Estimation of the Market Equilibrium and Economically Optimal Reserve Margins for the ERCOT Region for 2024

Responses to Questions and Comments

1/15/2020

Electric Reliability Council of Texas (“ERCOT”)

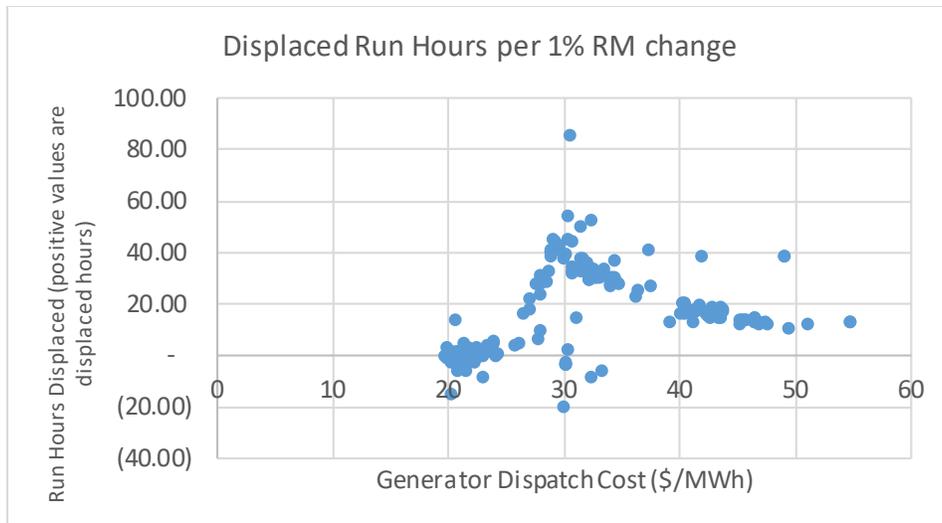
1. Comparison of the EORM charts for the 2018 and 2020 studies (copied below): What strikes me first is that in the old chart, the costs at 4% and 17% are about the same. In the new chart, the cost at 17% is way below the cost at 4%. So the two charts have a very different overall shape. The next thing that strikes me is that the new chart is mostly missing the "Production Costs (Above Base line)" which was a major component of the costs in the earlier chart. I actually think the newer chart makes more intuitive sense to me in terms of item one (costs at higher reserve margins are lower than costs at very low reserve margins), but I would like to get more info on both of these items.

2. There's a statement in the report (pp. 35-36) about since the marginal unit is now a CT, there are not much incremental production cost savings from additional new capacity. But I'm not sure I agree. A brand spanking new CT is a lot more efficient than the old gas units we have in ERCOT. Also, they don't have to run for 4 - 8 hours minimum.

Astrapé Response: I replaced the second chart with one that has a more comparable y-axis range and starts at 6% on the x-axis since the comparison needs to reflect the 2% shift (1% due to EFOR and 1% due to resource accounting). Comparing the total system cost at EORM to EORM + 6%

(that is from 9% to 15% in the 2018 study and from 11% to 17% in the 2020 study) is very similar between the two studies. ~\$200M in additional system cost in both studies. The difference is primarily in the emergency costs in the 2020 study at the low reserve margins. EUE at EORM minus 5% is 68GWh in 2020 vs 35 GWh in 2018. There are a few drivers of this change. One is more careful calibration of planned and maintenance outages. At reserve margins below EORM in this study, we begin to surface some non peak loss of load due to maintenance outages (we have 700 MW of MO in the summer on average; it's not present in the monthly peak, but on some shoulder peak days it can influence EUE in low reserve margin scenarios). The second is the inclusion of more energy limited capacity (1,100 MW of batteries) which gets exhausted more rapidly at low reserve margins.

The difference in 'production costs above the baseline' is primarily due to the previous study having CC capacity in the marginal resource additions. The CTs don't provide as much production cost savings. See response to the next question.

Astrapé Response: *There's a little bit of mis-attribution in our figures. The system production cost category has all production costs for conventional units, so as we increase reserve margin, conventional units serve some of the energy that was previously served by the emergency products, and this looks like an increase in cost for the conventional category even though it is a savings on the emergency side. A more nuanced analysis of the production cost savings that should be allocated to conventional units shows about \$2.5M per 1% RM near MERM instead of ~\$1.3M per 1% RM. This still wouldn't show up visually in the EORM chart since that's quite a bit smaller still than the production cost savings of the CCs we saw in the last study. For more info, here is a chart of the reduction in run hours for the gas fleet by dispatch cost of each unit. There is ~15GW of conventional capacity with dispatch cost > \$26/MWh (the dispatch cost of marginal CTs). Multiply that by average savings of 20 hours per year times average \$/MWh savings of ~\$8/MWh yields ~\$2.5M. Note: the run hour reduction per unit is small since we're analyzing the impact of 700 MW of CTs on a 15GW fleet. Marginal CTs have a capacity factor of ~9%.*
